September 29, 1998

ULNRC- 03902

**DOCKET NUMBER 50-483**  
**UNION ELECTRIC COMPANY**  
**CALLAWAY PLANT**  
**CHANGES TO ESFAS FUNCTIONAL UNIT 6.f**

FIGURE 1

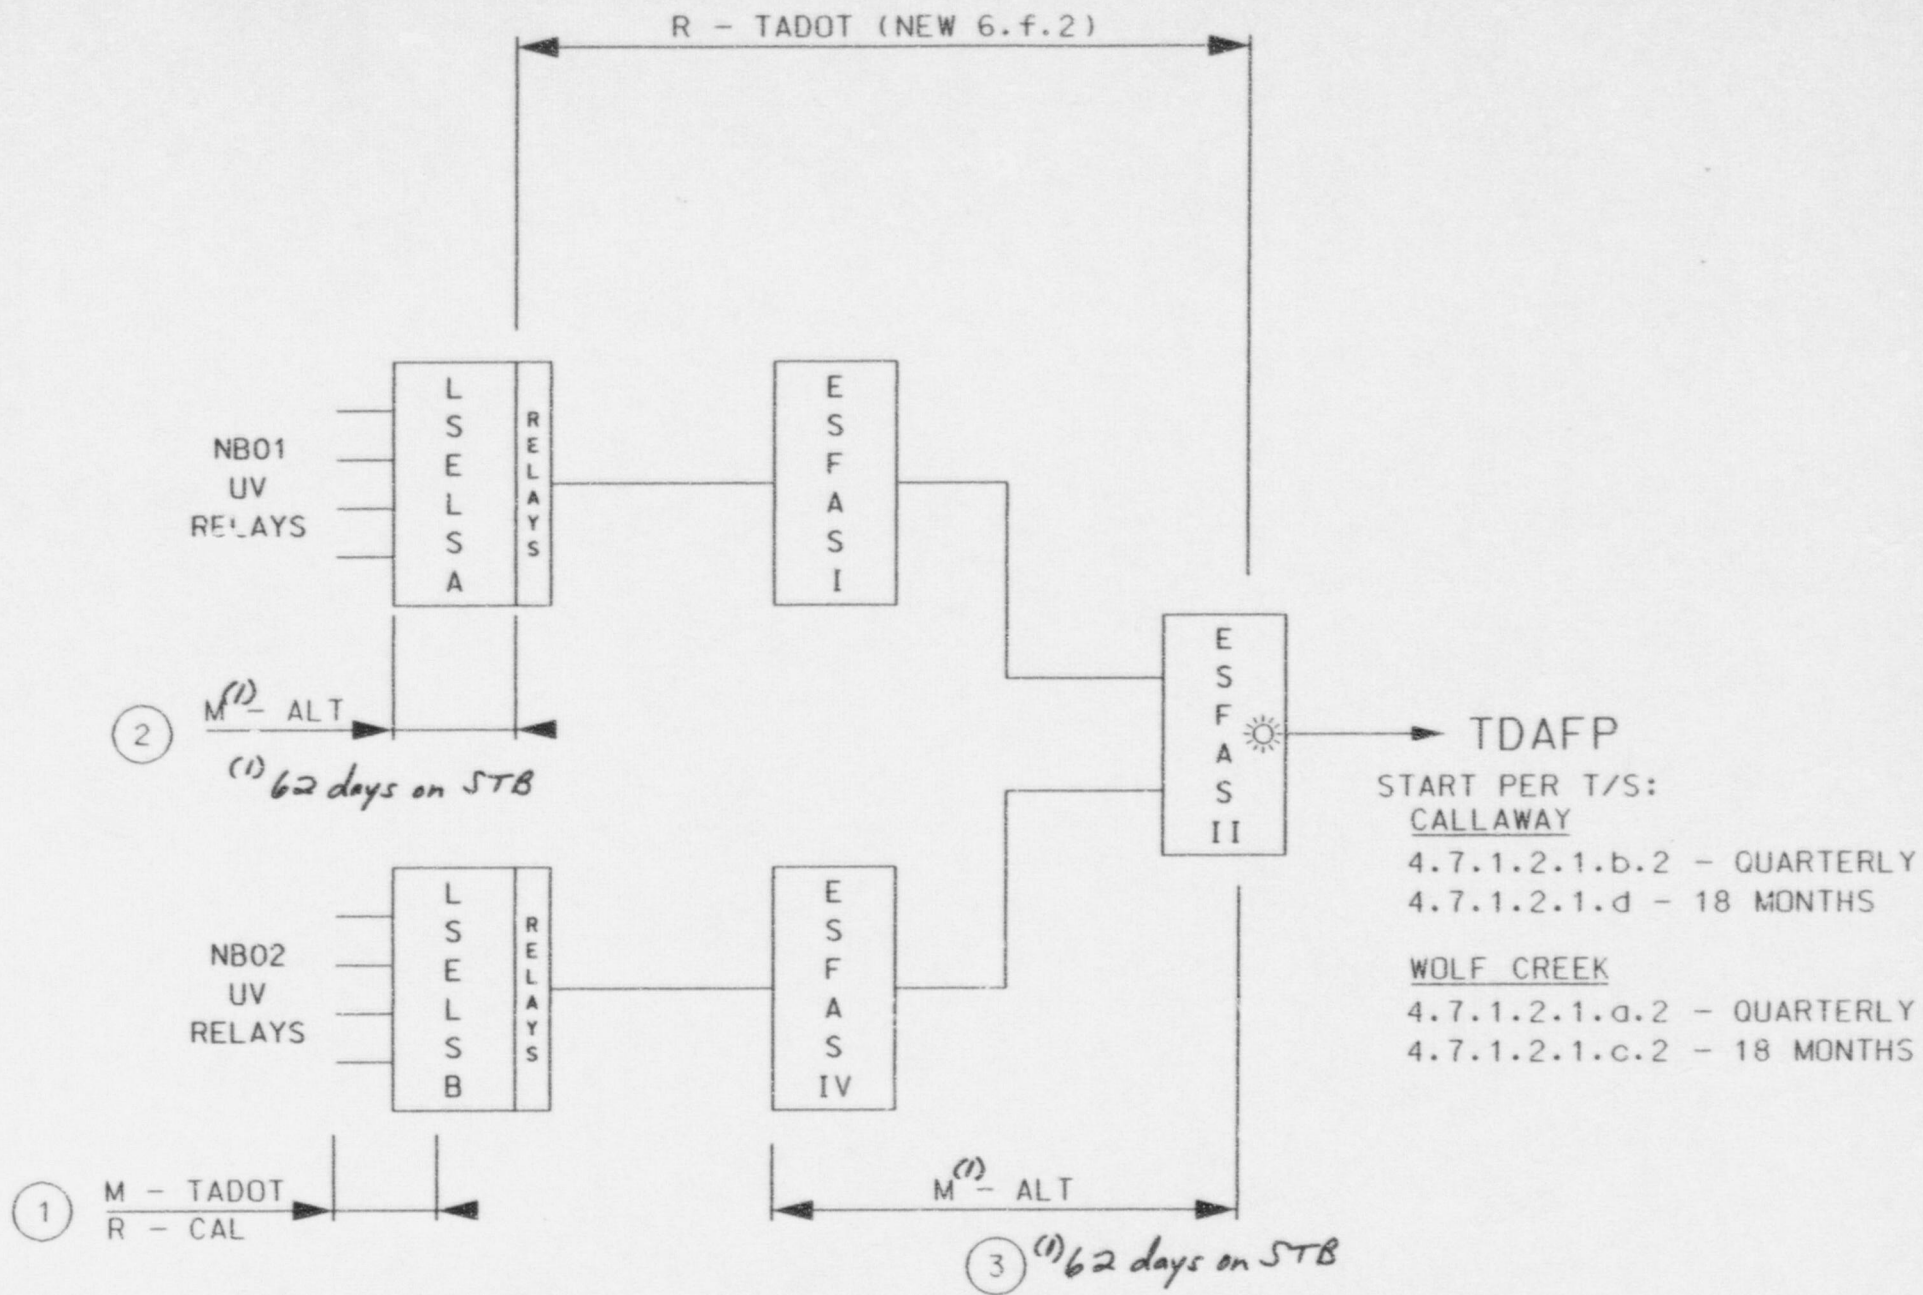
A loss of offsite power (LOP) is indicated by the undervoltage relays detecting a loss of voltage on each ESF bus, as discussed above. Upon satisfying the two-out-of-four loss of voltage logic in the LSELS cabinets, LSELS output relays feed the redundant separation groups 1 and 4 BOP-ESFAS cabinets as shown in the attached Figure 1. The separation groups 1 and 4 BOP-ESFAS cabinets perform several functions, as discussed above, but on a LOP signal these cabinets perform only two functions, i.e., the steam generator blowdown and sample lines are isolated and electrically isolated outputs are provided to the separation group 2 BOP-ESFAS cabinet. The separation group 2 BOP-ESFAS cabinet is only associated with the TDAFP and will continue to be considered part of that end device, i.e., the TDAFP, in the Technical Specifications. On a LOP signal, the turbine steam supply valves (ABHV0005 and ABHV0006) and the turbine trip and throttle valve (FCHV0312) are opened for the start of the TDAFP.

- ① TABLE 4.3-2, ITEMS 6.f & 8
- ② TABLE 4.3-2, ITEM 10
- ③ TABLE 4.3-2, ITEM 6.c
